To:	Marz Asgar	From:	Chris Rossiter
	Palmerston North		Christchurch
Project/File:	310003282 100.106	Date:	22 April 2022

**Reference: Whisky Creek Private Plan Change – Transport Engineering Review**

Attachment 1: RFI Response

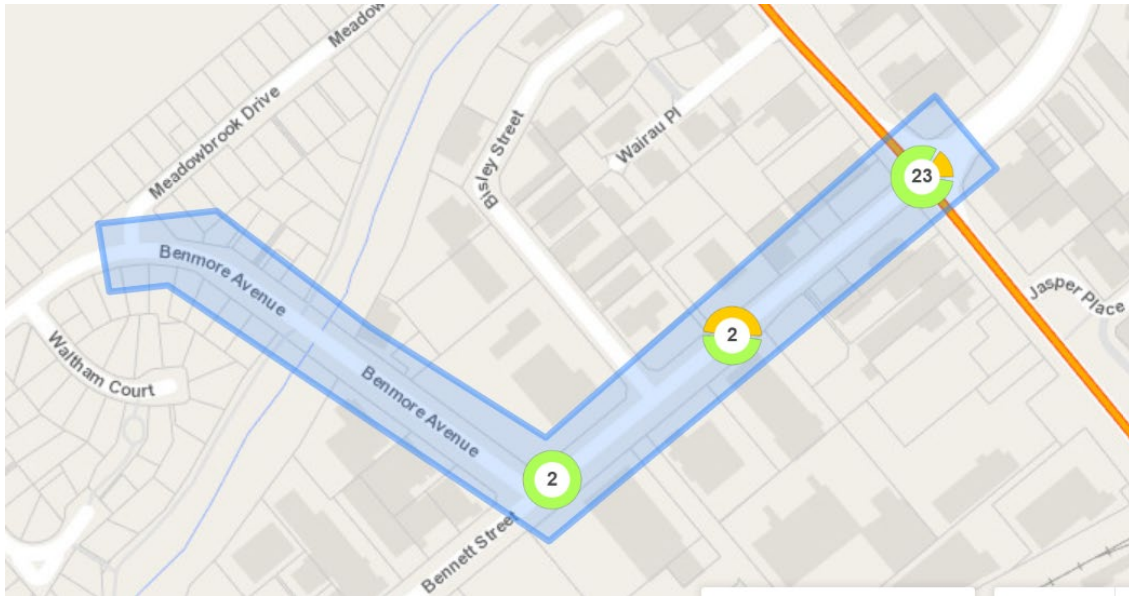
**8. Applicant to confirm what level of traffic growth has been adopted for intersection analyses.**

HF comment: An increase in traffic growth of 10% for traffic on Benmore Avenue between the 2017 traffic counts and the 2021 assessment year. An assessment with future year increases in traffic growth on Benmore Avenue was not undertaken as part of the transportation assessment. Council are actively seeking to deter through traffic from using Benmore Avenue and in the longer term measures included in the Palmerston North Integrated Transport Initiative (PNITI) are intended to encourage freight traffic off the central city streets providing some relief to existing rat-run routes such as Benmore Avenue.

Attachment 2: Signal controlled Intersection Concept

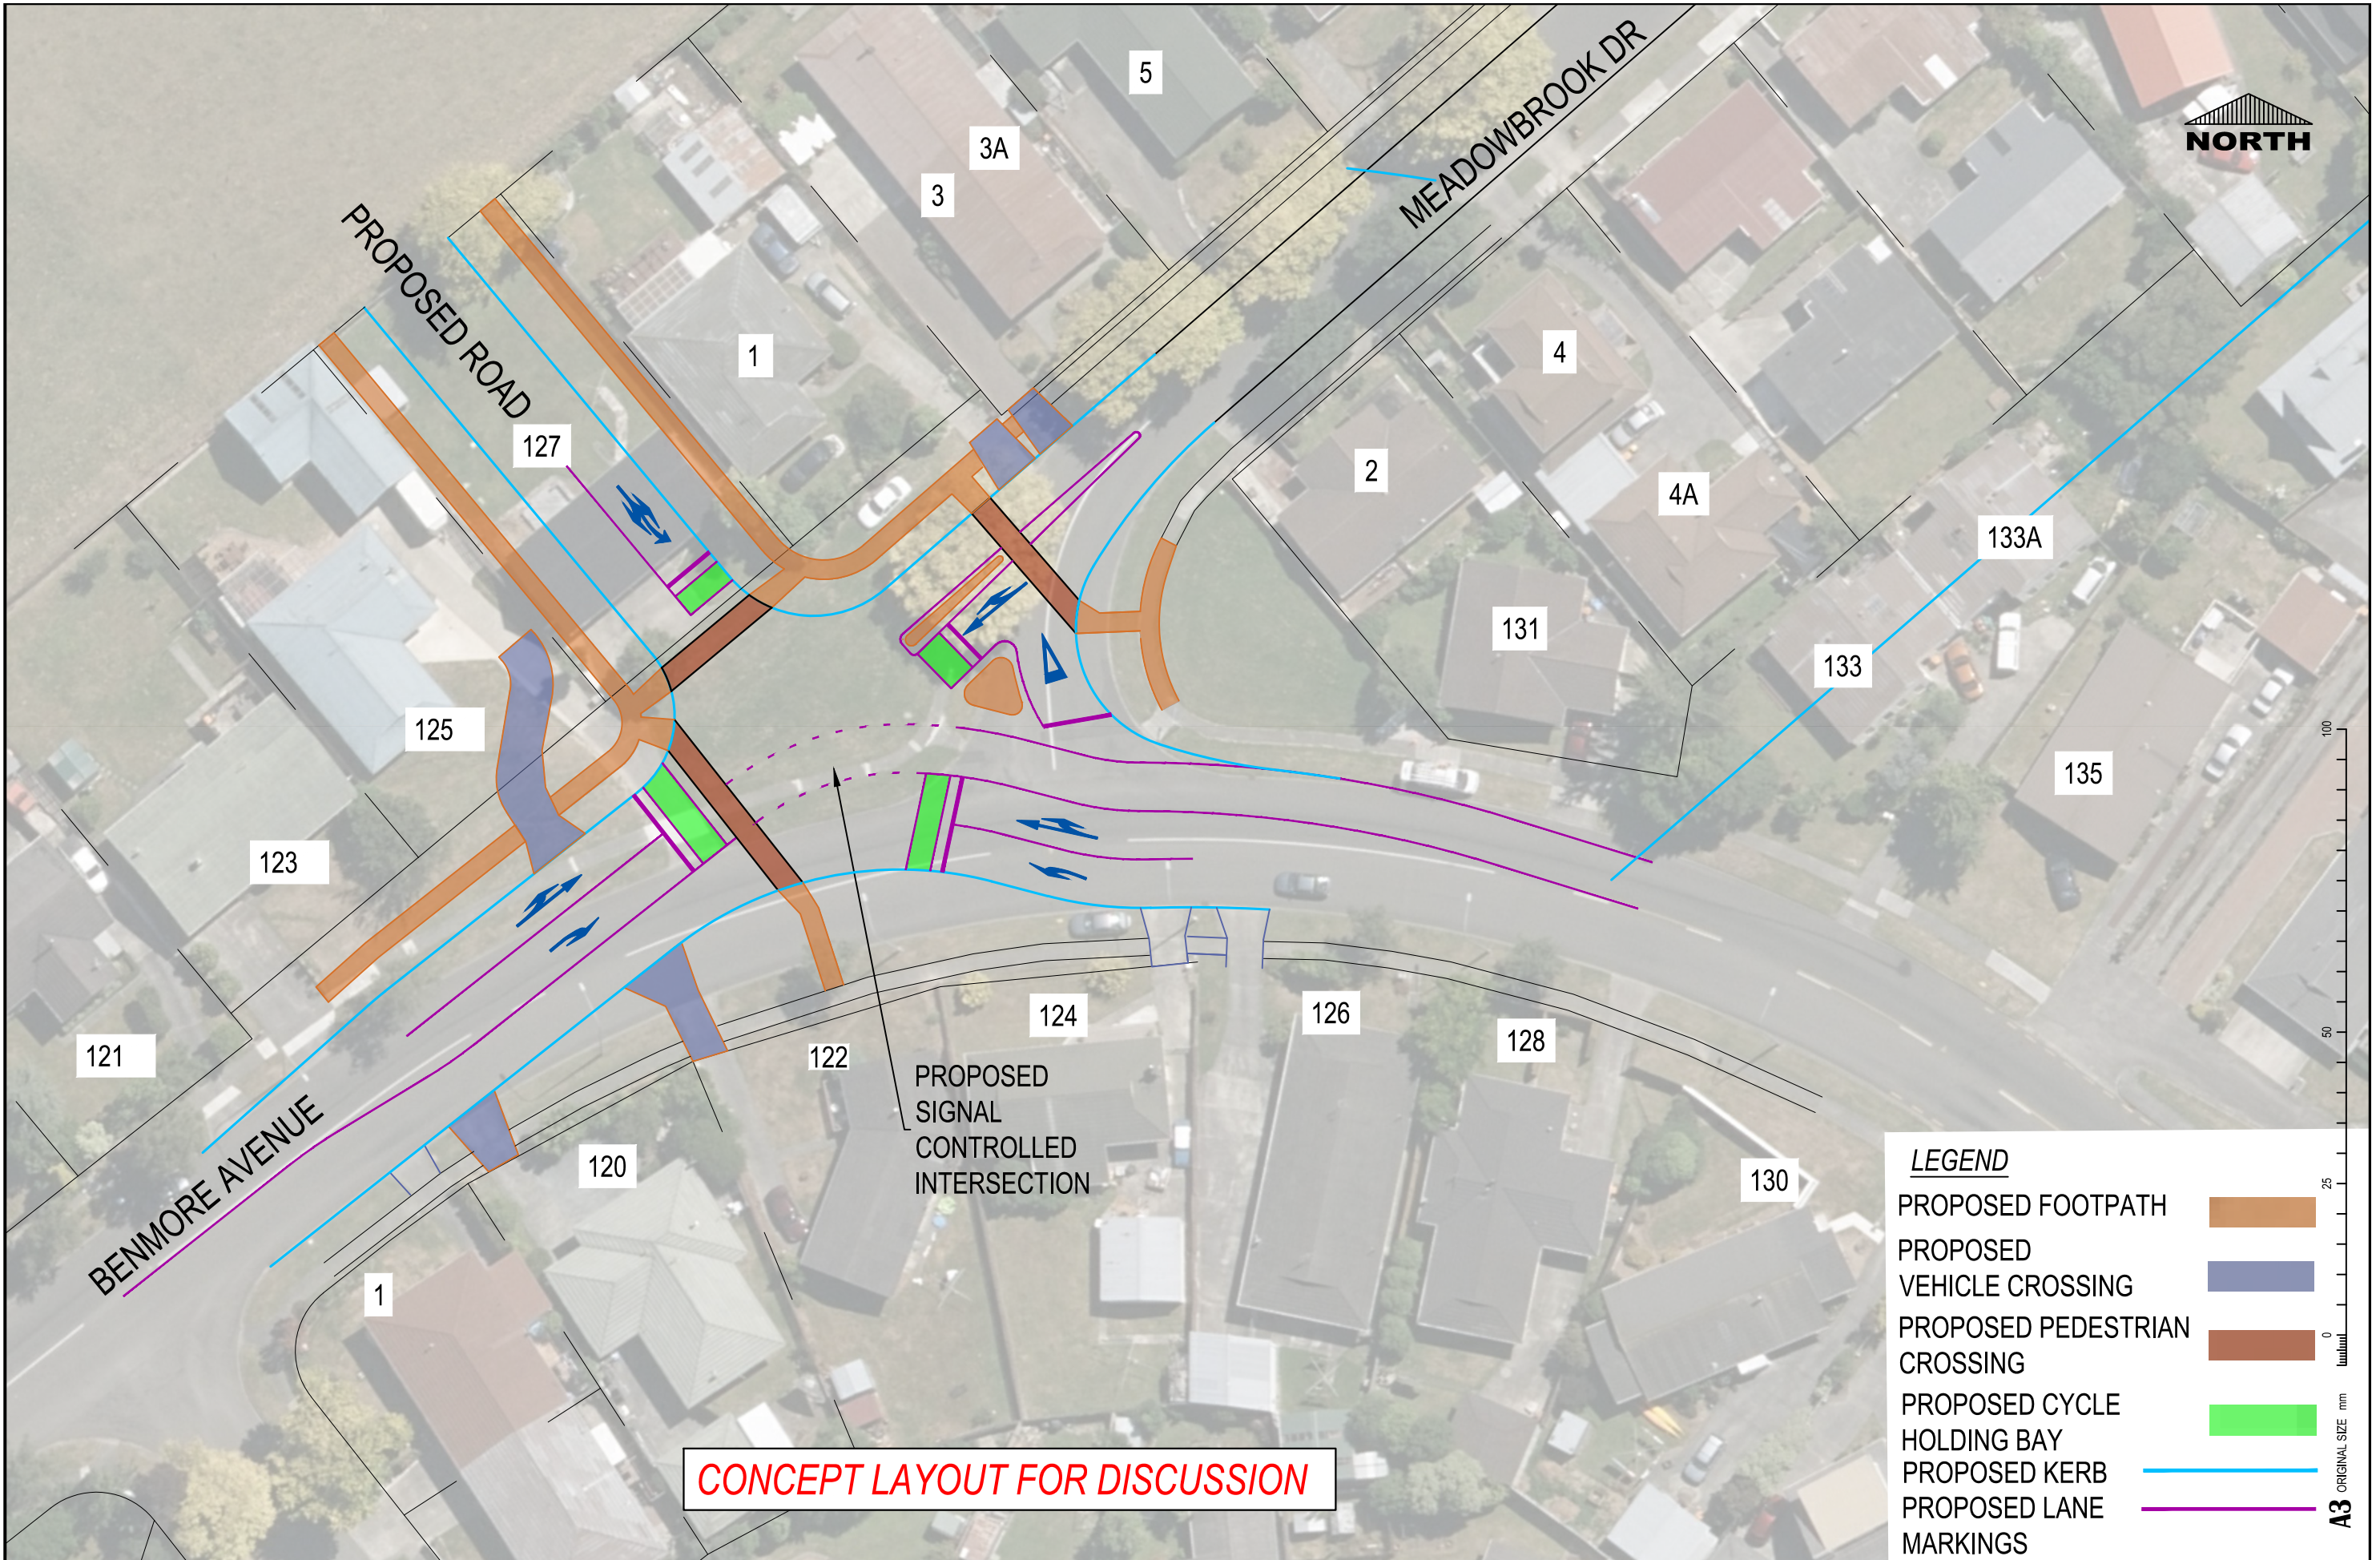
15. *Applicant to provide details of other intersection options that have been considered for this location.*

- a. *Although the approach flows are unbalanced, it is considered that a cross-roads intersection could operate efficiently because the overall flows remain low. With the low volumes, the higher number of conflict points represents less of a safety concern but could eliminate property access concerns.*
- b. *A concept design for a signalised intersection has been prepared that shows in principle that this represents a viable option.*
- c. *Overall, it is agreed that a roundabout is likely to represent the most efficient intersection configuration but as noted earlier, there are a number of safety concerns to be resolved.*

HF comment: With the intersection having four approaches, the only options are for it to be a roundabout or signalised. A cross-road arrangement is not considered feasible as the main traffic route will remain along Benmore Avenue and cross-road intersections have a high number of potential conflict points. A signalised arrangement has been sketched up and will be provided separately.
